# 1990 Corvette: Service Bulletin: Clicking Noise When Steering Wheel is Rotated

**Subject:** 'CLICKING' NOISE WHEN STEERING WHEEL IS ROTATED

**Model and Year:** 1990 CORVETTE

**Bulletin Number:** 90-327-3B - (08/03/1990)

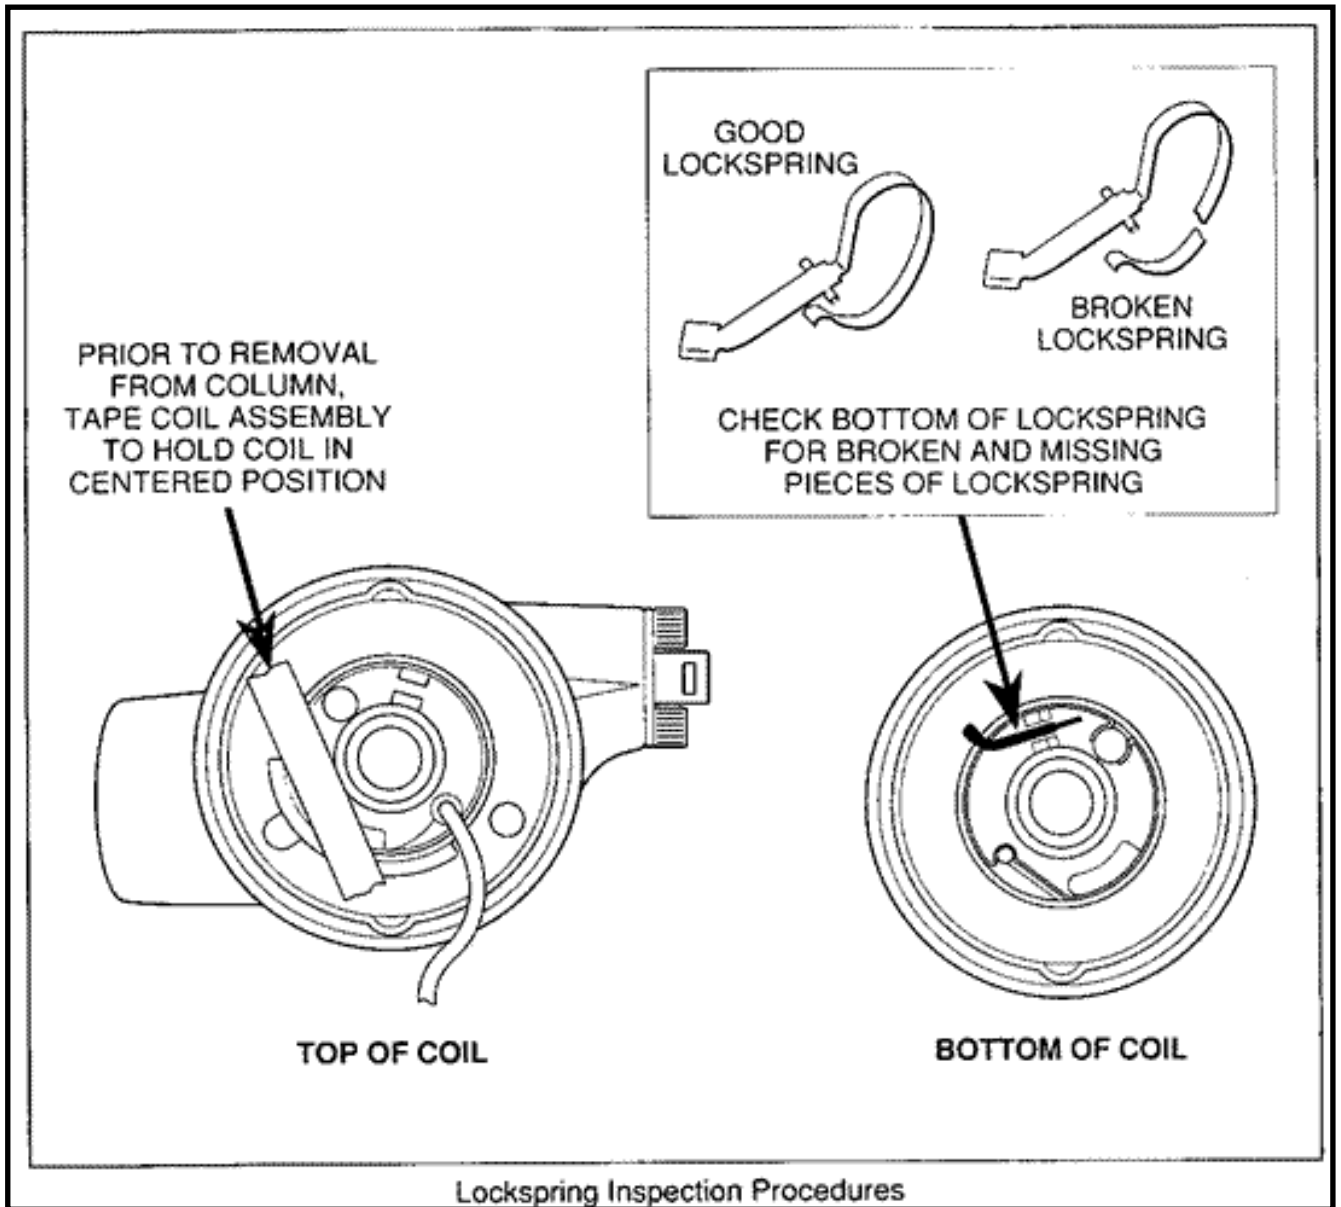
4. Refer to 1990 Corvette Service Manual for complete instructions on removing the coil assembly from the steering column. Before removing the coil assembly from the column, tape the coil assembly to hold it in the centered position, as shown in the illustration.

5. Remove the coil from the column, turn the coil over, and inspect the lockspring for broken or missing pieces as shown in the illustration.

a. If the lockspring is black, it is not subject to breakage. Leave the lockspring in place.

b. If the spring is brass colored, and is not broken, leave it in place.

c. If the spring is brass colored, and is broken, remove all the pieces of the spring and discard. It is not necessary to replace the lockspring with a new one.

**NOTICE: All pieces of the broken lockspring must be removed, or serious damage to the steering column may result.**
